## **PLANNING COMMISSION MEETING**

<b>Farmington Planning Commission Staff Report</b>	<b>Meeting Date:</b> November 10, 2025	<b>Reference Number</b>
<b>Submitted by:</b> Chris Weber, Assistant City Manager		
<b>Agenda Item:</b> Dental Office Project at 31030 and 31036 Grand River SPR		
<p><b><u>Requested Action</u></b></p> <p>a. Move to approve the site plan for the Dental Office Project at 31030 and 31036 Grand River as proposed, with the following waivers and deviations pursuant to Section 35-208:</p> <p style="padding-left: 40px;">i.</p> <p>OR</p> <p>b. Move to approve the site plan for the Dental Office Project at 31030 and 31036 Grand River with the following modifications:</p> <p style="padding-left: 40px;">i.</p> <p>OR</p> <p>c. Move to deny the site plan for the Dental Office Project at 31030 and 31036 Grand River, for the following reasons:</p> <p>.</p>		
<p><b><u>Background</u></b></p> <p>The proposed Dental Office project at 31030 and 31036 Grand River requires review and recommendation by the Grand River Corridor Improvement Authority and approval by the Planning Commission. The entire site is an existing non-conforming site. The plan proposes a full interior renovatio

# A012

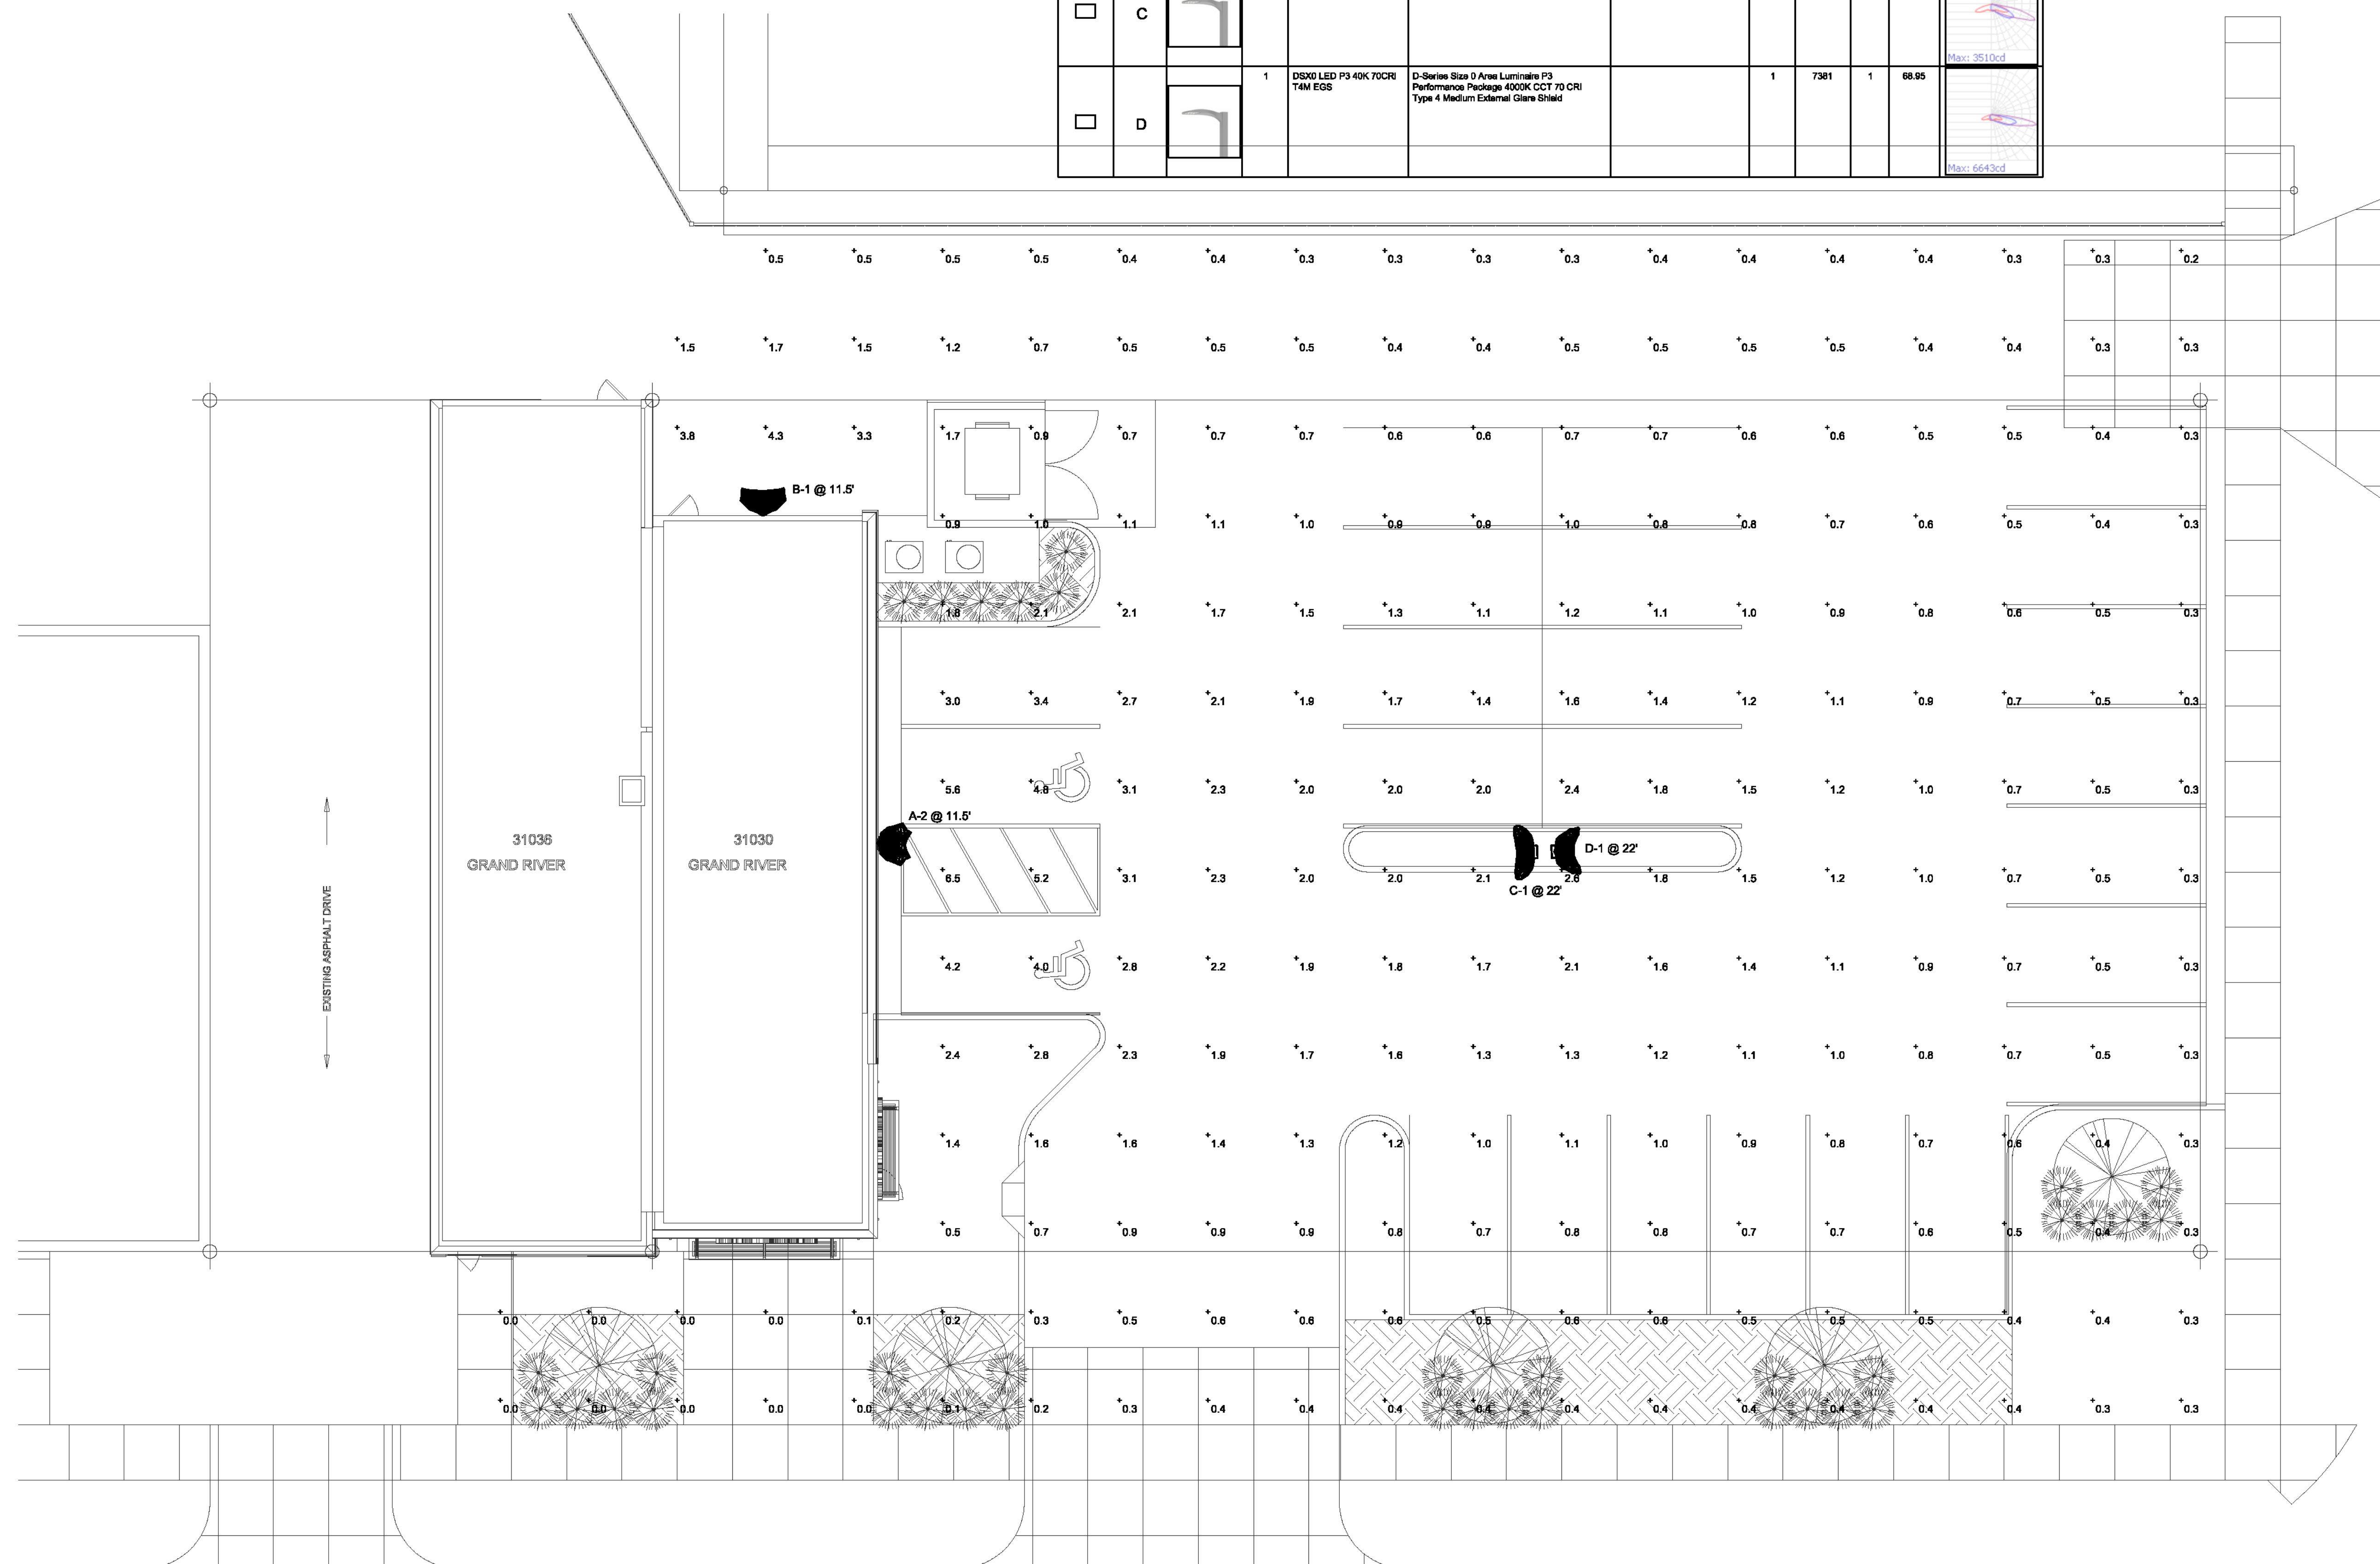
1. **Exterior Lighting (§35-48).** The site plan indicates that “no site lighting currently exists on this site.” Sheet A012 indicates one (1) shielded wall-mounted fixture is proposed for the north elevation, one (1) shielded wall-mounted fixture is proposed for the east elevation, and two 22’ high pole-mounted shielded lights are proposed for the parking lot island. The maximum height of parking lot light fixtures shall be 20’, and the site plan must be revised to comply with pole height requirements. Additionally, two (2) unshielded surface mounted LED light fixtures are proposed for the south elevation, and two (2) unshielded surface mounted LED light fixtures are proposed for the east elevation – no lighting details were provided for these light fixtures.

- a. **22’ high pole light fixture will be revised to 20’-0” max height and lighting details will be provided for the unshielded surface mounted LED fixtures on the south and east elevation.**
